Re: SSD-80211463 for 164-172, 174-194 William Street WOOLLOOMOOLOO NSW 2011

Mixed use development with in-fill affordable housing, 164 – 194 William Street, Woolloomooloo

Figure 2 – Actual location of viewpoint 9 with markups included

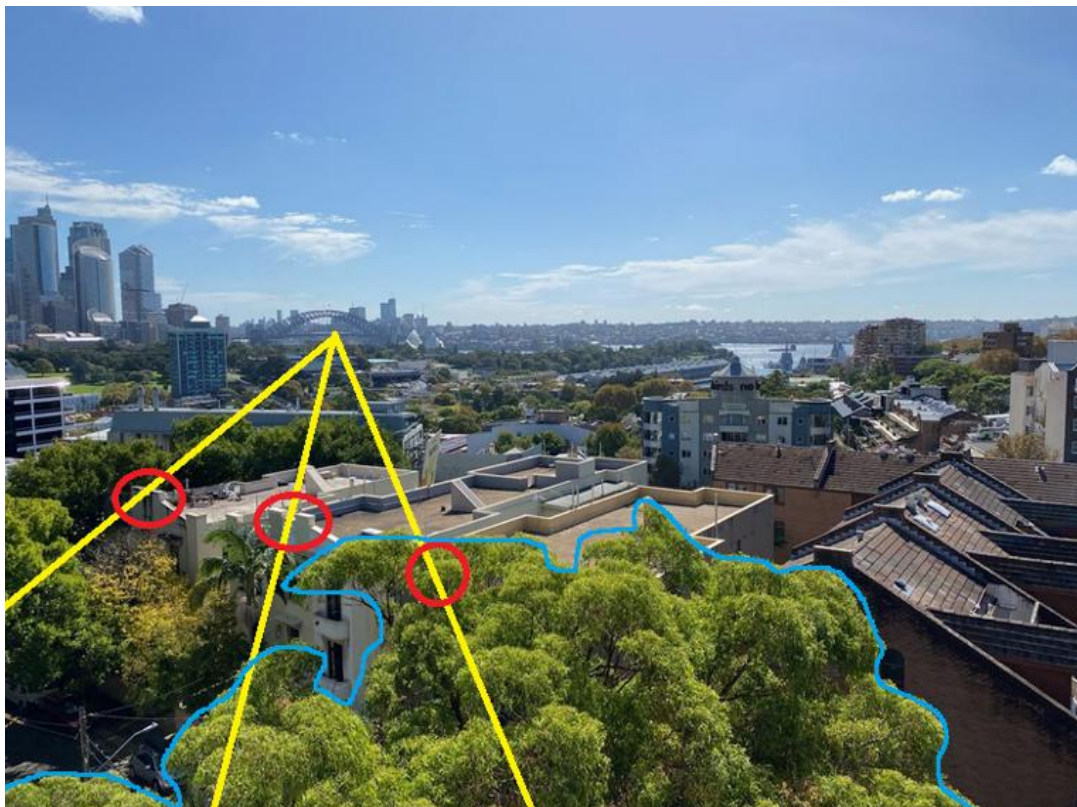
The following photo was taken by us in April 2023 using an iPhone camera, from the actual location of the balcony of Unit 22 on level 5 (7th storey equivalent). This unit is on the north-west corner on our level and the photo was taken standing on the balcony behind the balustrade. Markups have been overlaid for guidance:

The blue outline shows the large tree located at the front of our building. The yellow lines have been extrapolated through key points of the buildings across the road towards the Harbour Bridge to provide additional context regarding the balcony's true position in relation to its surroundings.

In the actual balcony position (Figure 2), the direct line of sight to the Harbour Bridge intersects the centre between the 2nd and 3rd yellow lines. In comparison, the developer’s photo (Figure 3) places this alignment well to the right.

Figure 5 - Viewpoint 9 according to Urbaine Designs with our markups

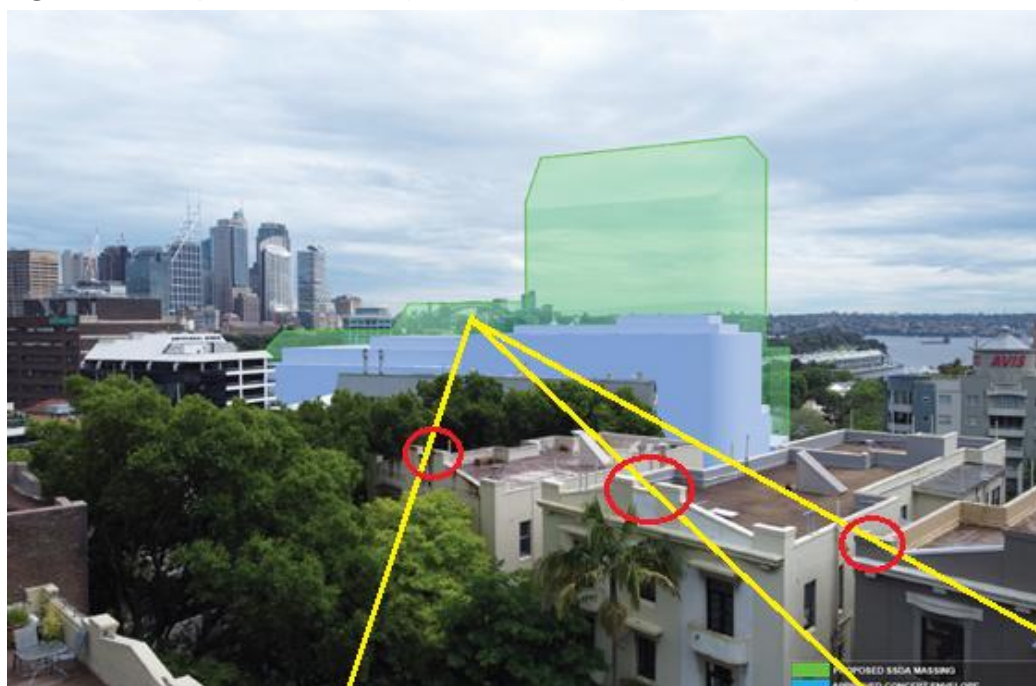
At level 5 (7th storey equivalent), the Harbour Bridge is now completely obscured due to the increase in height of the buildings step-down. Levels 6 and above, however, may still appear to retain visibility through the stepdown due to the exaggerated angle. While the significance of this inaccuracy may be debated, it remains important because it is both **misleading and creates an illusionary impression** of retained view for the north-west balconies and particularly given that there are two additional sets of north facing balconies extending further to the east.

Figure 6 – viewpoint 12 drone vantage point

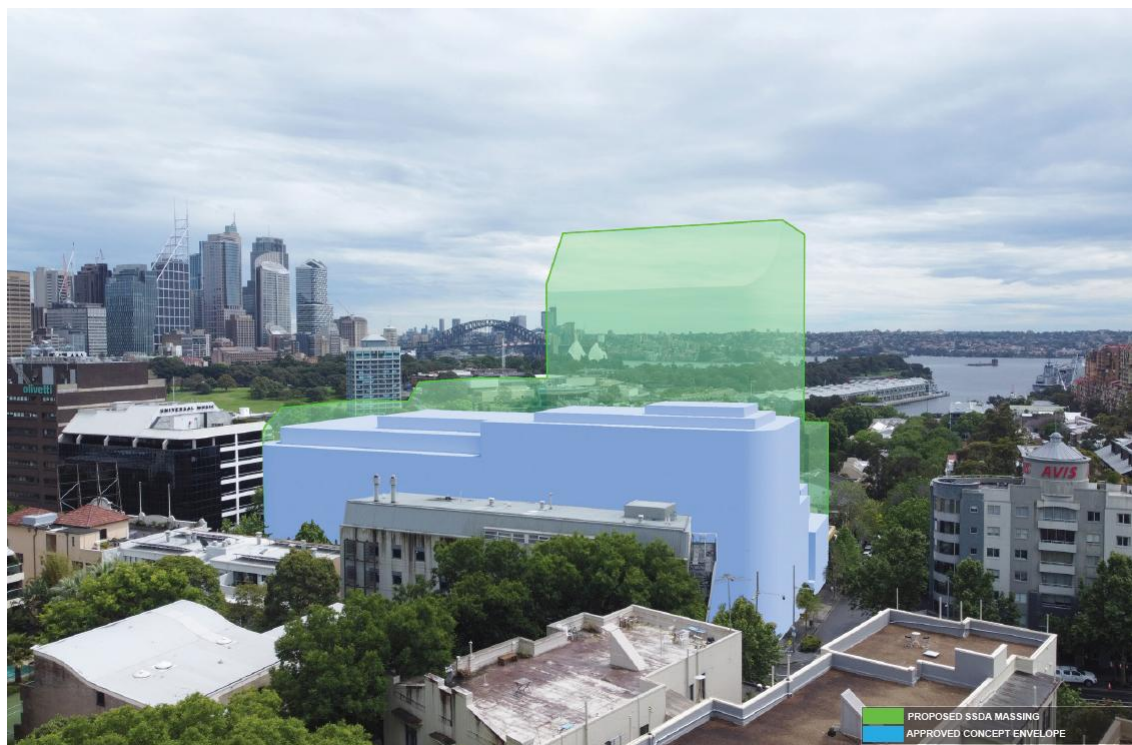
The actual balconies, along with the two additional sets of balconies to the east of the north-western balcony, are now likely to have the remaining iconic landmark (Harbour Bridge) partially or completely obscured. It is **deeply concerning** that even a penthouse apartment on level 9 (11th storey equivalent), positioned near the top of the Darlinghurst rise, would see the top of the proposed development protruding above the highest part of the city skyline!

Figures 11 – 18 – Various Urbaine Design photo snippets near building step down

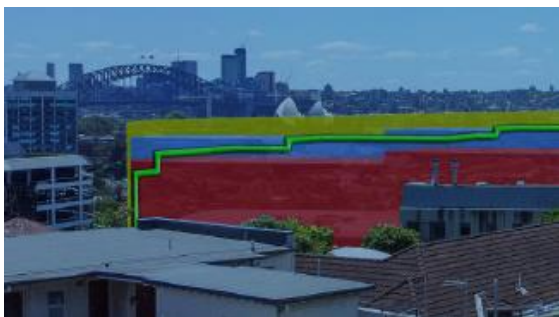
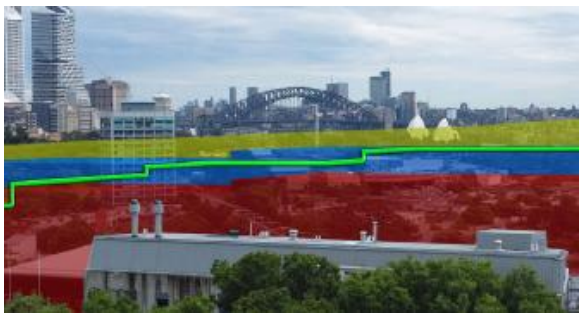
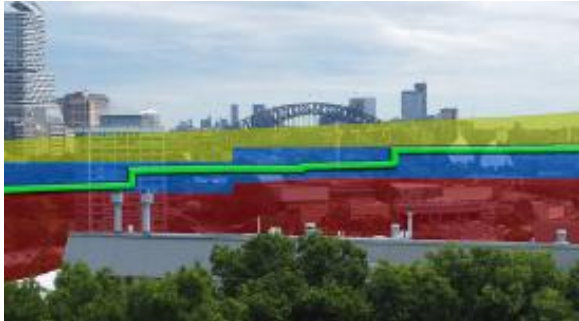
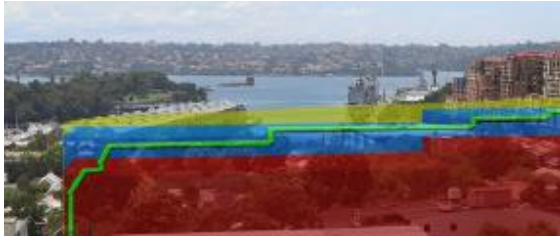
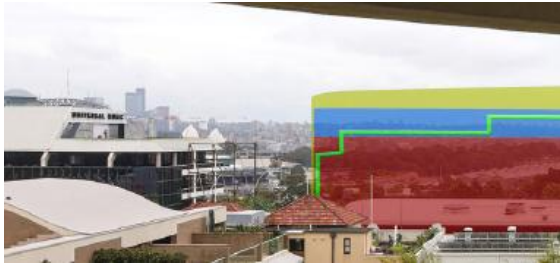
Several other vantage points in the *View Impact Assessment* appear to intentionally focus on retaining a view of key landmarks such as the Harbour Bridge, Opera House, or Fort Denison, near a step-down in the proposed building. However, these points of interest would be unlikely to be visible in the omitted properties.

One would conclude that **photos were biased** towards vantages favouring less severe view impacts for the benefit of the developer in securing approval. The same vantages are used in the new *View Impact Assessment*.

Figure 23 – Front aspect of Palisades North Tower with location of unit 24

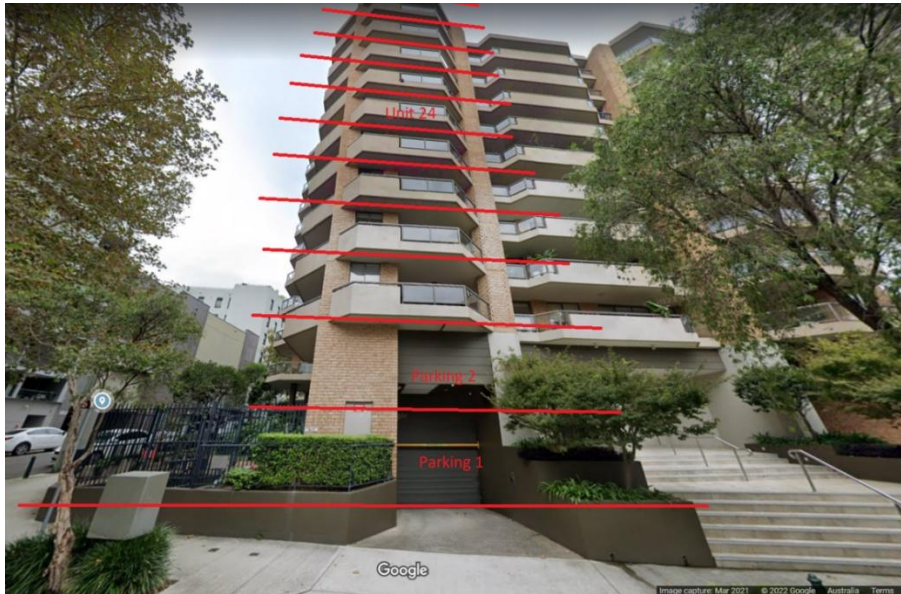
The photo below illustrates the aspect and view of our apartment - unit 24, level 5 (7th storey equivalent) of Palisades North Tower, 5-15 Farrell Avenue. This photo was taken from our front balcony, behind the balustrade. Our unit is located on the north-east corner of the Palisades North Tower.

Figure 24 – View impact from proposed building envelope on unit 24

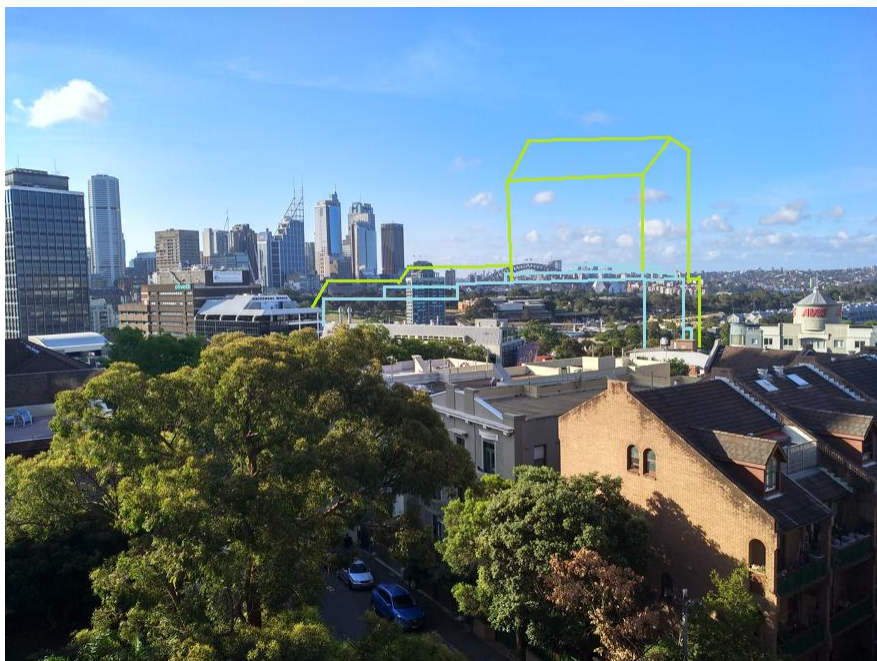
The next is based on the photo from Figure 22 and includes an outline estimation of the form of the newly proposed building envelope (in blue) compared to the approved concept (in green). When comparing this with the developer's representation of unit 22 in *Figure 6 - viewpoint 12 drone vantage point*, which is on the same level as ours, it demonstrates a reasonable accuracy of replication, with the building slightly rotated to reflect the differing angle from our unit.

From this, it can be seen that the approved concept envelope allowed a partial view of the upper arch of the Harbour Bridge, whereas the new envelope blocks it entirely.
